Additional Site Investigation Work Plan

Bright Cleaners Tenant Space
7249 South 76th Street
Franklin, Milwaukee County, Wisconsin

DNR FID #241928940
DNR BRRTS #02-41-580017

2.0 RESPONSE TO DNR COMMENTS

FIGURE
1

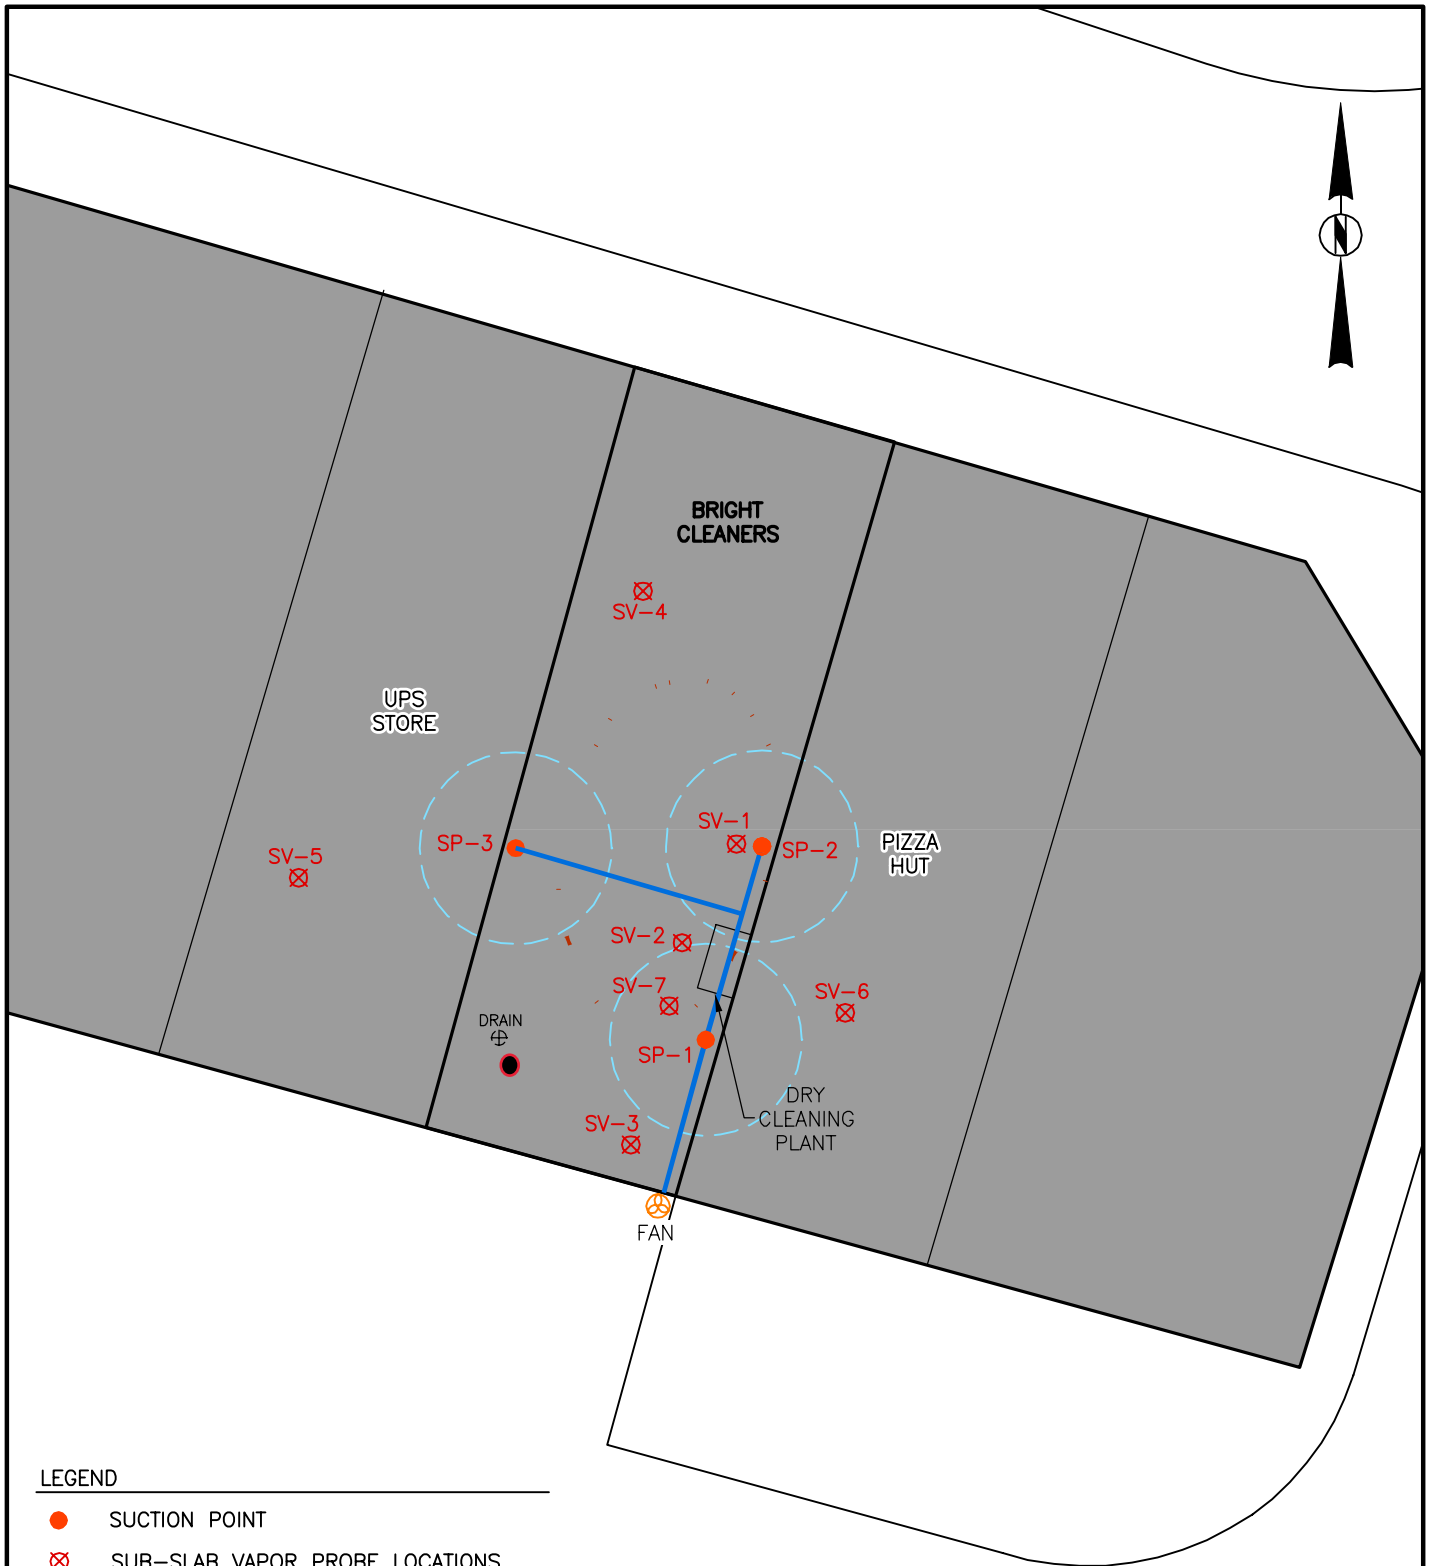
Additional assessment of utilities is necessary to complete the site investigation. Complete an assessment to determine whether utilities located at the site are acting as a source of contamination and/or a preferential migration pathway. Provide the location of all floor drains located within the former Bright Cleaners tenant space and the location of utility laterals within the former Bright Cleaners tenant space and adjacent tenant spaces.

Two weeks after capping the exhaust pipe of the SVE system, Apex will collect six soil-gas samples immediately below the concrete floor slab in and adjacent to the former dry cleaner tenant space. One soil-gas sample will be collected from the following locations shown in Figure 1:

SV-1, SV-4, SV-5, SV-6, SV-7 and proposed SV-8 adjacent to bathroom floor drain.

The only utilities beneath the floor slab within the tenant space are a floor drain (sanitary line) and a water line that feeds the sink and toilet within the bathroom at the back of the store. Apex proposes to collect an additional soil sample and sub-slab vapor sample in the vicinity of the floor drain. The attached figure shows the floor drain and proposed sample location.

See response to comment 1. A soil sample will be collected adjacent to the bathroom floor drain. Soil boring logs will be provided with the updated Site Investigation report (SIR), along with documentation of the collection of soil samples HA-1, HA-2 and HA-3.
